Monk Lakes Groundwater Assessment

Maidstone Borough Council

Maidstone Borough Council (MBC) appointed Mott MacDonald to undertake an assessment of a groundwater investigation carried out by Peter Brett Associates (PBA) in conjunction with BAM Ritches Ltd for a recreational fishing site known as 'Monk Lakes', at Staplehurst Road, Marden, Maidstone, Kent, TN12 9BU.

Figure 4.1: Monk Lakes site with southern limit of River Terrace Deposits

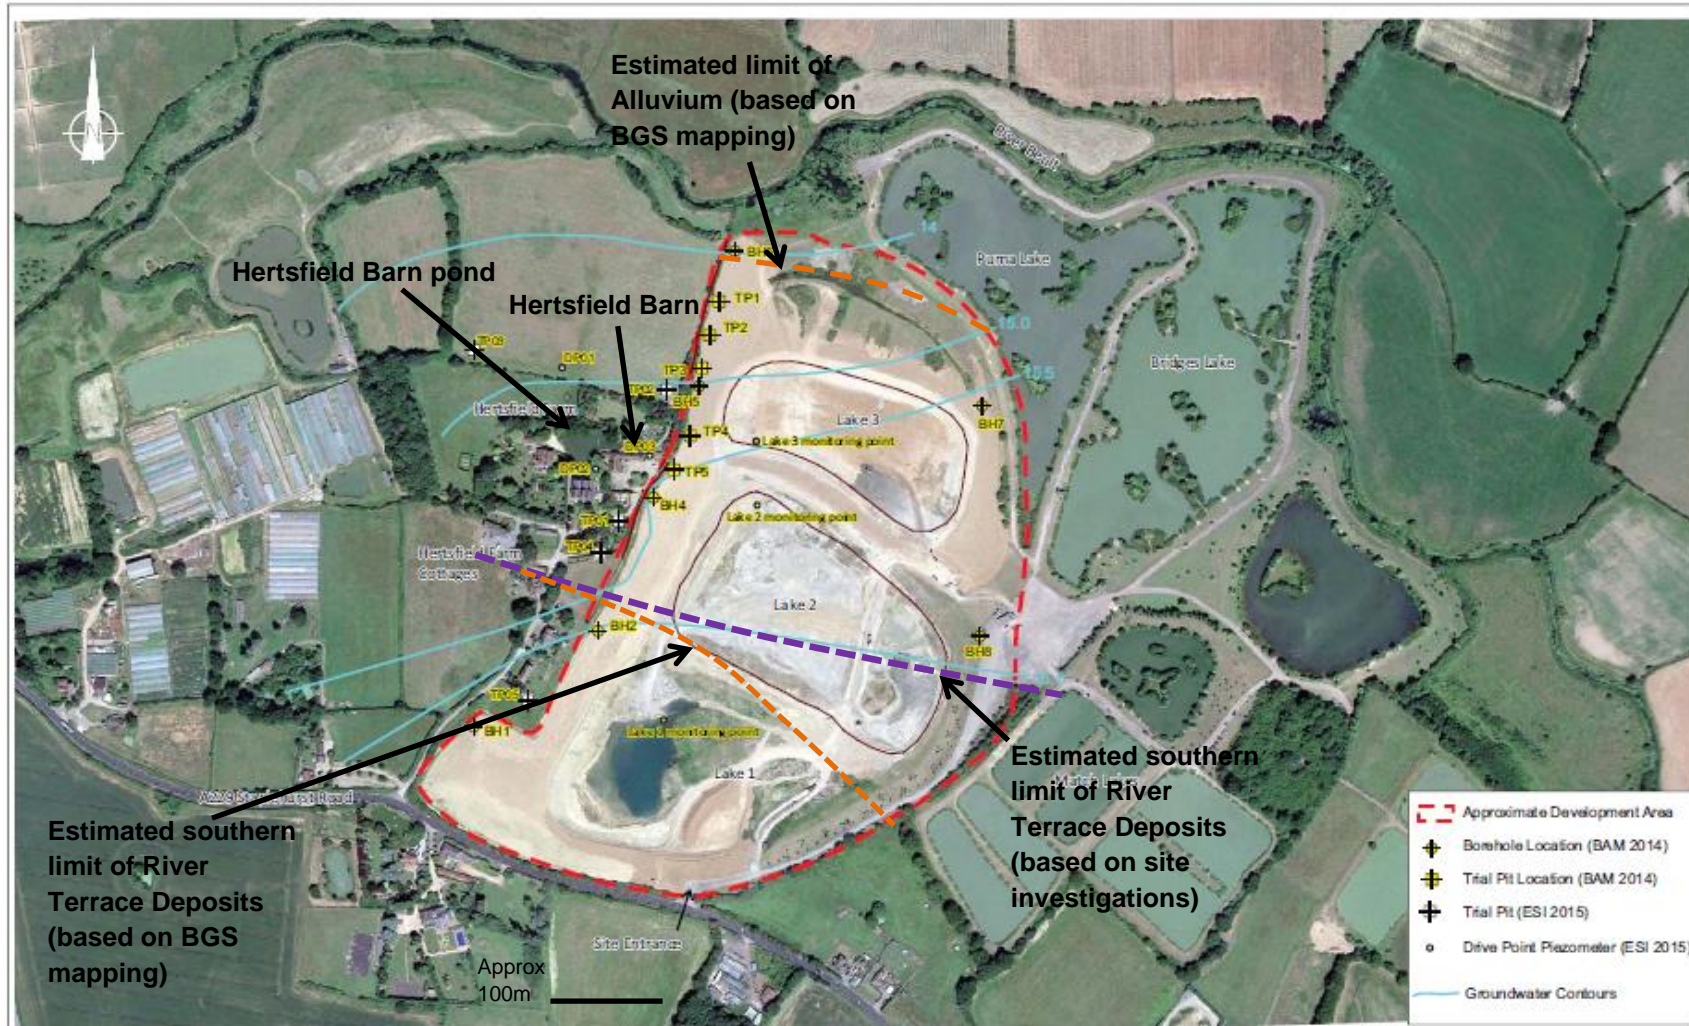
From this investigation alone, it is not sufficiently clear where the southern limit of the River Terrace Deposits is located, other than that it is somewhere between BH 2 and 4.

The ground investigations carried out by BAM Ritches Ltd agree with the geology expected from BGS mapping under the site itself. However, as no boreholes or trial pits were constructed by them on land not owned by Monk Lakes Ltd, the geology of the land to the west is unproven by them. Evidence is presented in ESI (2015) and so this evidence should be used in conjunction.

No trial pits or boreholes were constructed by BAM Ritches Ltd between BH2 and BH4, and thus the southern limit of the River Terrace Deposits was poorly constrained. Using ESI's (2015) data in addition constrains the southern limit of the River Terrace Deposits more precisely, and provides evidence that approximately the northern half of Lake 2 is constructed on River Terrace Deposits, with the southern half on Weald Clay. The extent of the River Terrace Deposits is important to define as it informs whether Lake 2 was mostly constructed on the River Terrace Deposits or Weald Clay, how close to Hertsfield Barn the boundary lies, and how it relates to the notable change in the 15.5mAOD groundwater contour discussed in Section 4.3.2.

1. At least one more trial pit/borehole should be dug on the western boundary between BH2 and BH4 in order to better constrain the southern limit of the River Terrace Deposits and corroborate the information from ESI (2015). Suggested locations for this borehole are shown on Figure 4.3.
2. The nature of the fill used to construct the lakes should be ascertained.
3. A geophysical survey could be carried out across the site, in an attempt to better define the extent of the River Terrace deposits. However, additional boreholes are likely to achieve this in addition to providing groundwater level information.
4. The statement in 4.3.2 of Peter Brett Associates (2015) that access permission was not granted on Mr Padden's land should be rephrased as, from available correspondence between the two parties, who refused access to whom appears to be contentious.

Figure 4.2: Monk Lakes site with groundwater contours

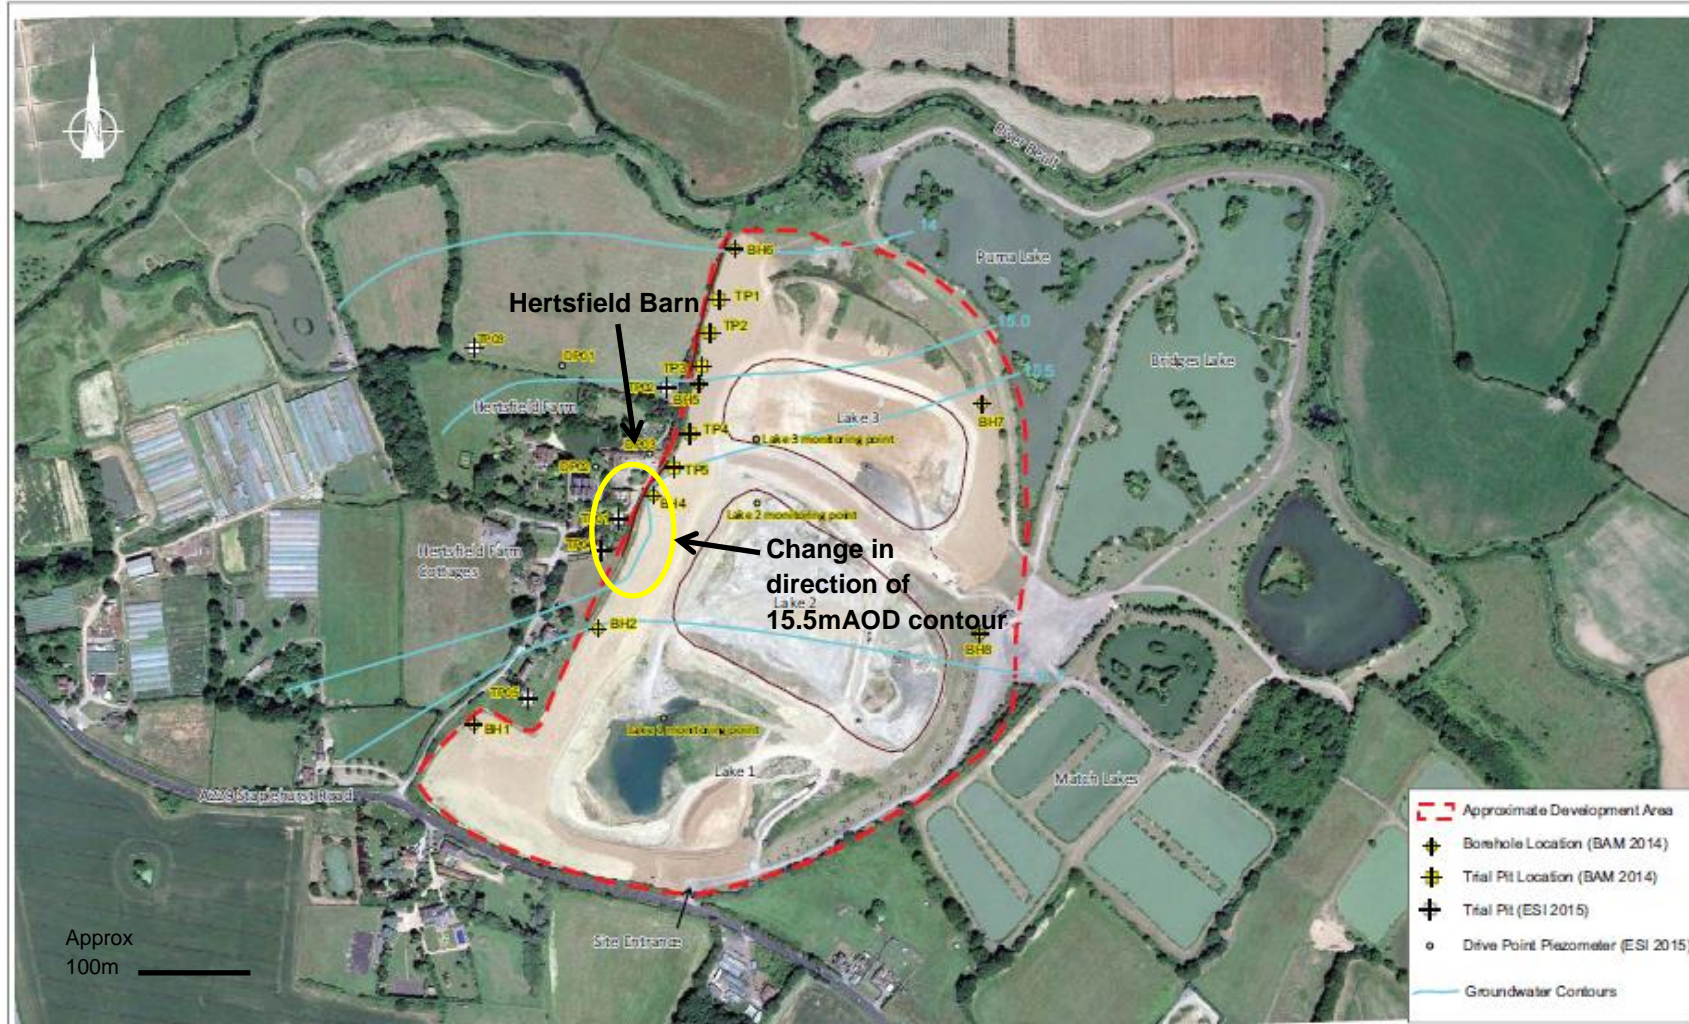
Figure 4.2 of this MM Report shows groundwater contours of the area as constructed by Peter Brett Associates (2015), including ESI (2015)'s data. This shows that groundwater levels are generally higher in the south of the area and fall towards the north. Groundwater flow is thus also expected to be towards the north, towards the River Beult, as would be expected. The River Beult itself flows towards the west.

However, it is notable that the 15.5mAOD contour shows a very large change in direction to the west of Lake 2, and the contour is predicted to run along the western boundary. The shape of this contour implies that in this area groundwater will flow from east to west, rather than north towards the river. This contour implies that groundwater levels at Hertsfield Barn are around 0.5m higher than expected.

The change in contour shape in this area is not directly commented on, nor explained in PBA's report. It is implied that it may be a result of the western boundary ditch acting as a source of groundwater recharge. This is also stated in ESI (2015).

The contours are based partly on groundwater readings from the ESI 2015 study. PBA state that the ESI data may be unreliable as the piezometer installation methods are not considered to be in accordance with standard practice. Water levels at the ESI boreholes were only measured once. The change in direction of the 15.5mAOD contour is not apparent by plotting PBA's data in isolation. However, there is no alternative data available to the west to justify discounting ESI's readings.

Peter Brett Associates (2015) does not include groundwater readings from BH1 or BH2 in their report Figure 8 (which only shows contours within the River Terrace Deposits). However, in their Figure 9 contours (also reproduced in Figure 4.2 of this report) groundwater contours are shown extending through BH2, where the River Terrace Deposits are absent. The justification for extending the contours outside of the River Terrace Deposits is not explained.

Groundwater monitoring has shown that generally groundwater flow in the River Terrace Deposits is approximately north towards the River Beult. This is as would be expected. However, the change in the shape of the 15.5m AOD contour to the west of Lake 2 is notable, and implies that groundwater has the potential to flow towards the west in this area. This could have implications for groundwater flooding on land to the west where the land is also known to be locally depressed. This change in contour direction is additionally near the limit of the extent of the River Terrace Deposits in a part of the site that is less well understood owing to the absence of any boreholes. The shape of the 15.5m AOD contour is developed based on a single measurement from the ESI (2015) investigation integrated with the PBA (2015) data. Further work needs to be carried out in this area.

8. The contours drawn by PBA in Figure 9 of their report extend through BH2, where there are no River Terrace Deposits present and no groundwater was found. It is recommended that the River Terrace Deposit geology is shown on this figure and that contours are either not interpolated outside of this geological area, or justification for them is presented.
